APPLICATION NO.	FILING DATE	FIRST NAMED INVENTOR	ATTORNEY DOCKET NO.	CONFIRMATION NO.
10/676,982	10/01/2003	Christian L. Belady	10018060-3	7690

Office Action Summary

DETAILED ACTION

Figure A: The modified figure corresponds to figure 6 with flushed surface shown

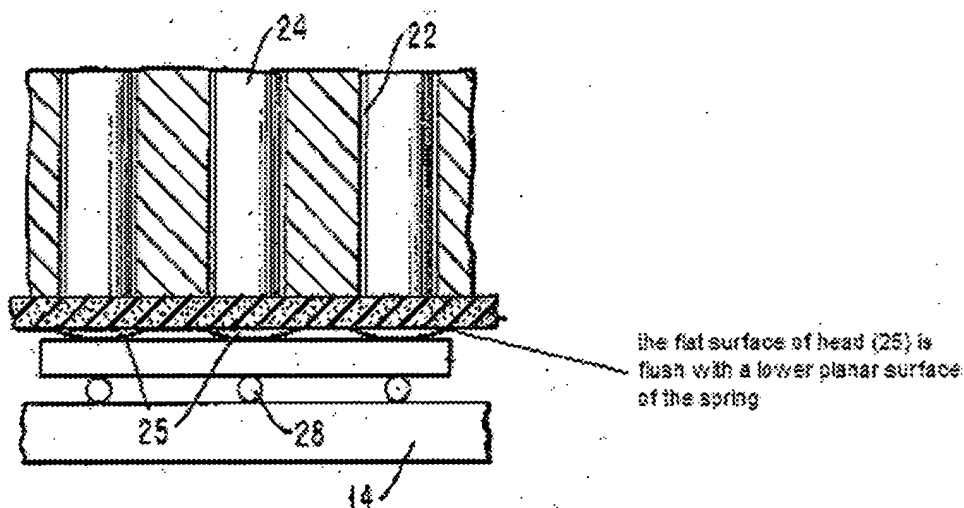
Applicant's arguments filed 4/19/2005 have been fully considered but they are not persuasive. Applicant's argument that the spring element (36) in Chu'281 is not flush to any head of the pin (24) has been very carefully considered but is not deemed to be persuasive because Chu'281 discloses (figure 6) that the lower planar surface of the spring element (36) is flush with a flat surface of the pin head (25). See figure A bellow.

Figure B: The modified figure corresponds to figure 2 of Chu' 358 with limitation shown

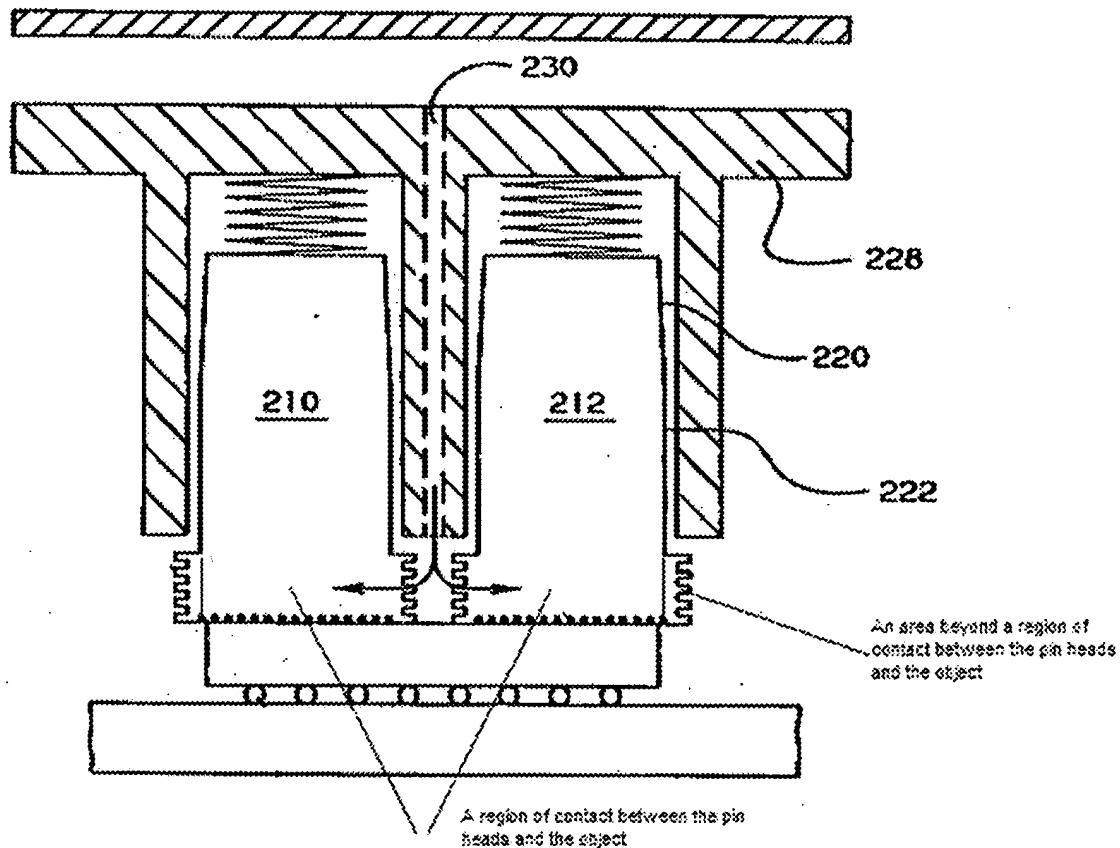
Regarding claim 12, applicant's argument that Chu'385 fails to disclose "the pinheads arranged in geometric pattern that covers an area extending beyond a region of contact between the pin

heads and the object" has been very carefully considered but is not deemed to be persuasive.

Chu'358 discloses figure 2 that the pins (210,212) have their heads arranged so that the pinheads also covers an area extending beyond a region of contact between the pin heads and the object.

(See figure B bellow).
